KILLARNEY WASTE DISPOSAL

ARTICLE 12 REQUIREMENTS WASTE LICENCE APPLICATION WASTE LICENCE 217-1

DOCUMENT CONTROL SHEET

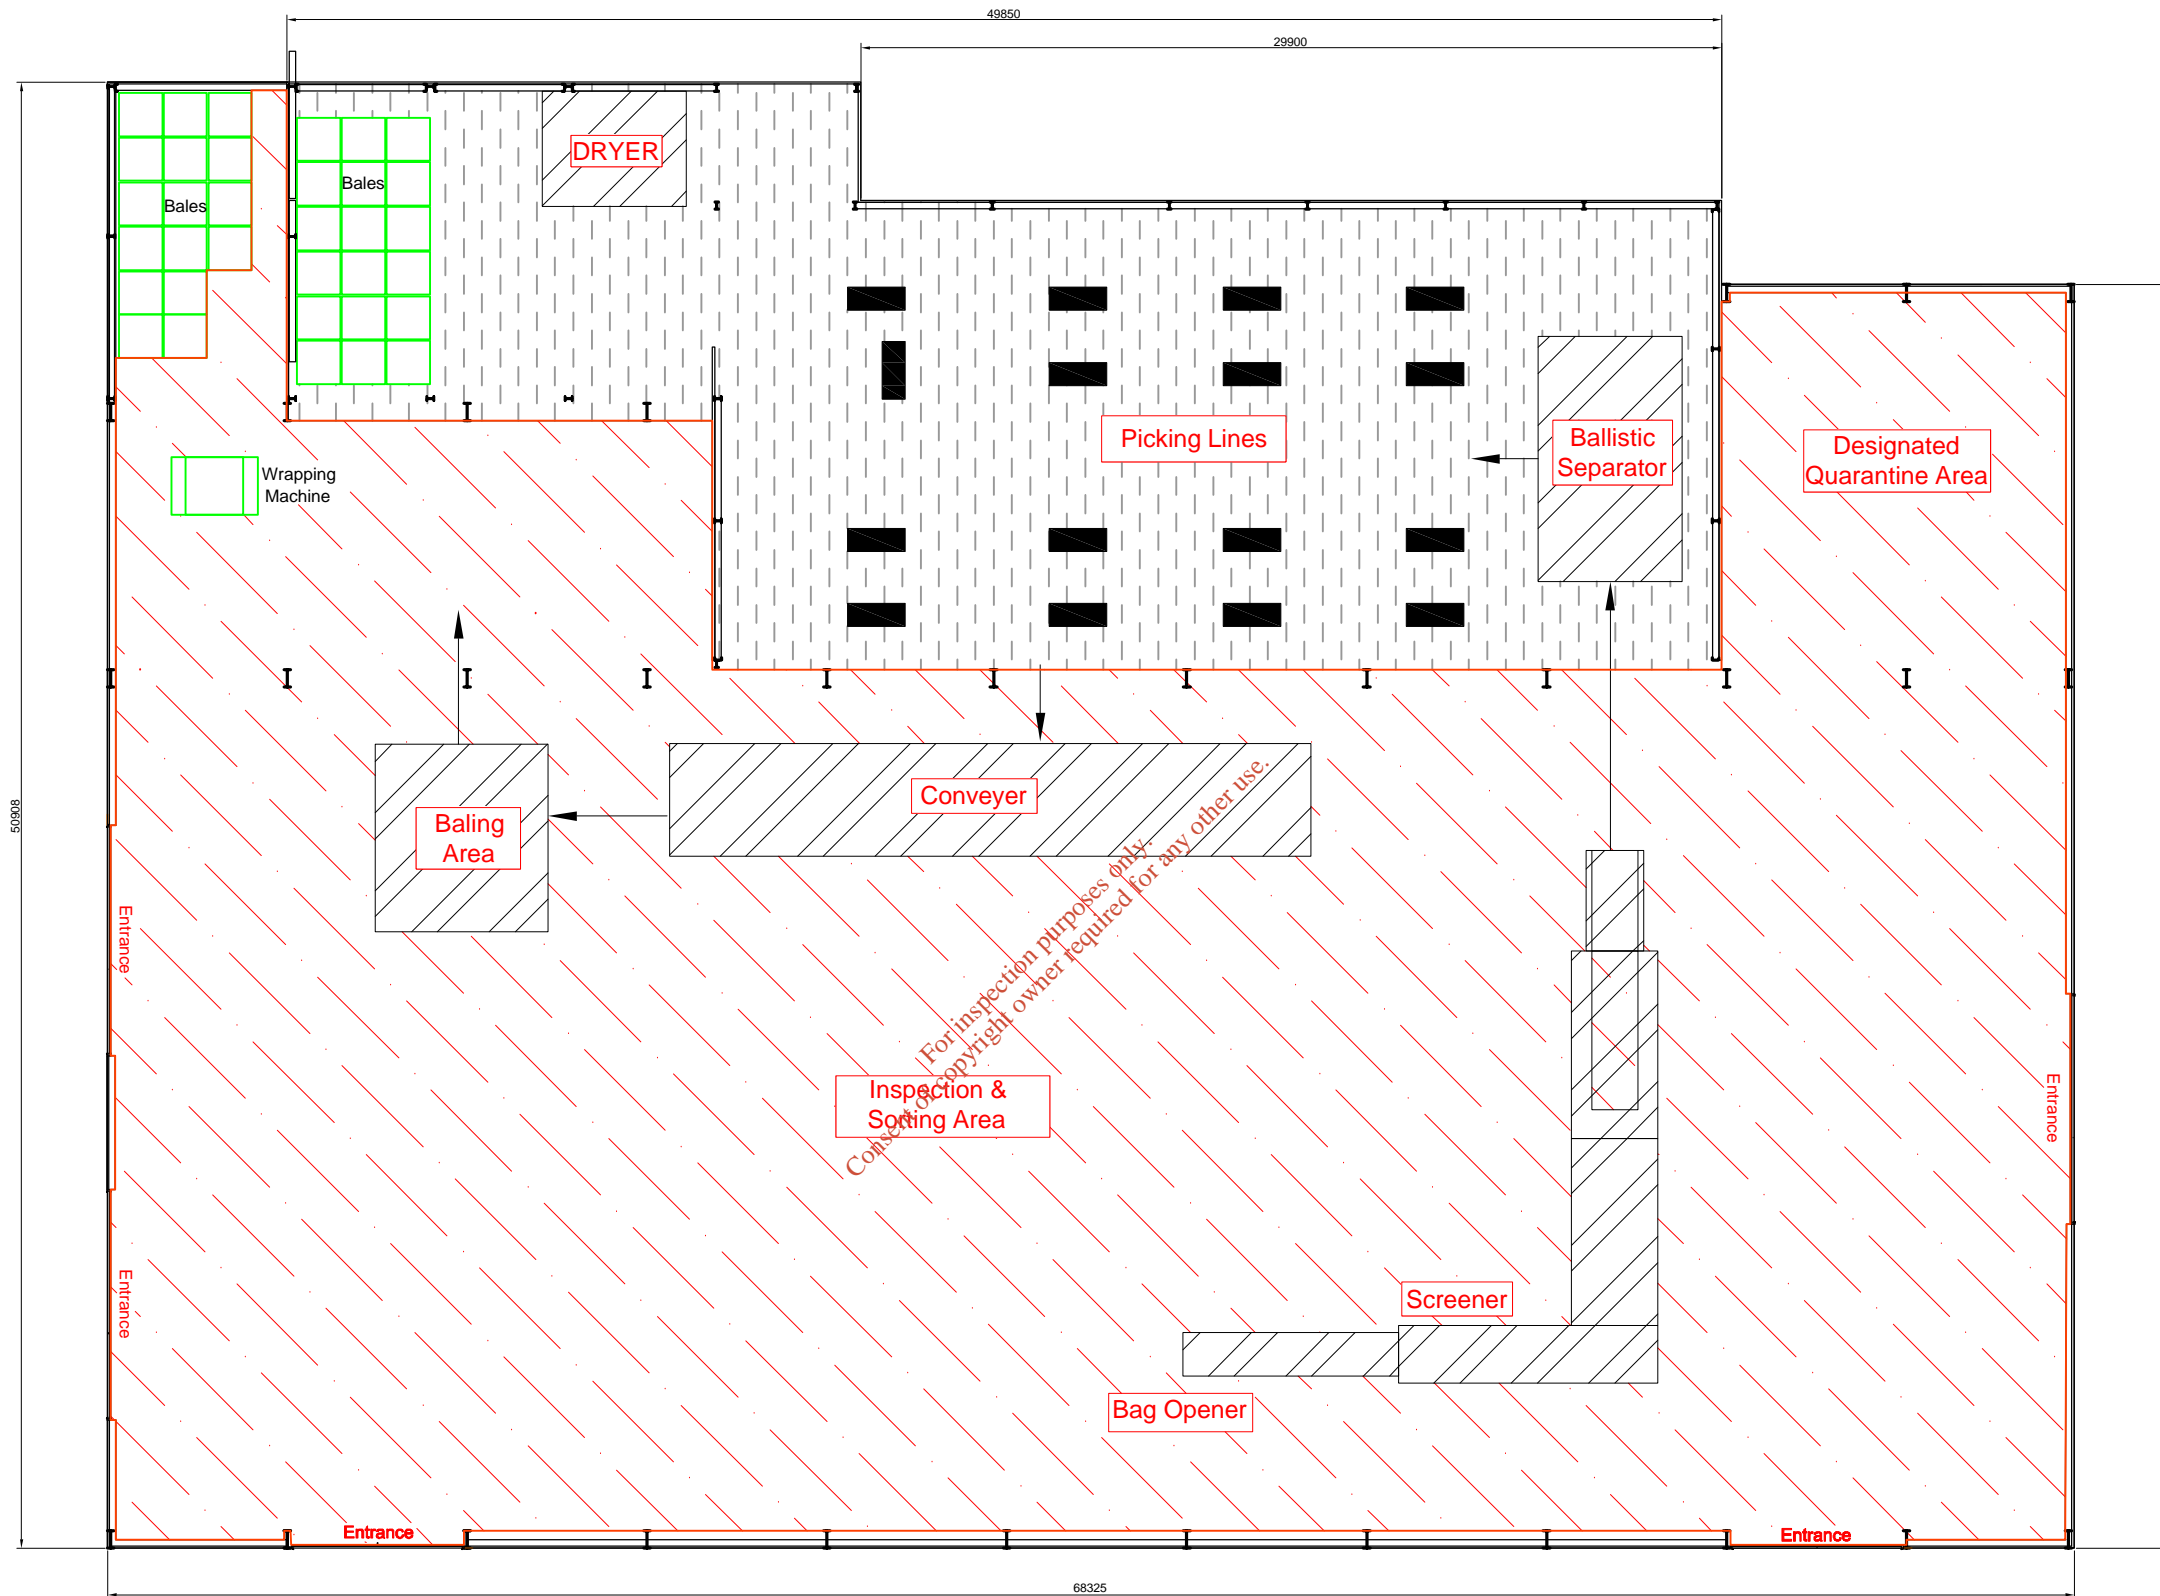
D1g: Give details of the final disposal route for domestic effluent from the puraflo. Drawing No. 02-034-J4-MCOS2 does not show storm drainage from the roof of the materials recovery building. Resubmit drawings with roof water drainage details. Give details of proposed trade effluent holding tank and indicate the location of the tank on a plan. Give details of drainage and treatment of run-off from any proposed outdoor storage and processing areas.

The final disposal route for domestic effluent from the puraflo is to a percolation area which is described in Section 6 F1b. Drawing No. 02-034-J4-MCOS2 has been updated to include the roof water drainage details from the materials recovery building, proposed effluent holding tank within the materials recovery building, details of drainage and treatment of run-off from the proposed outdoor metal storage area. Appendix D provides the design details for the new effluent holding tank and surrounding bunding tank.
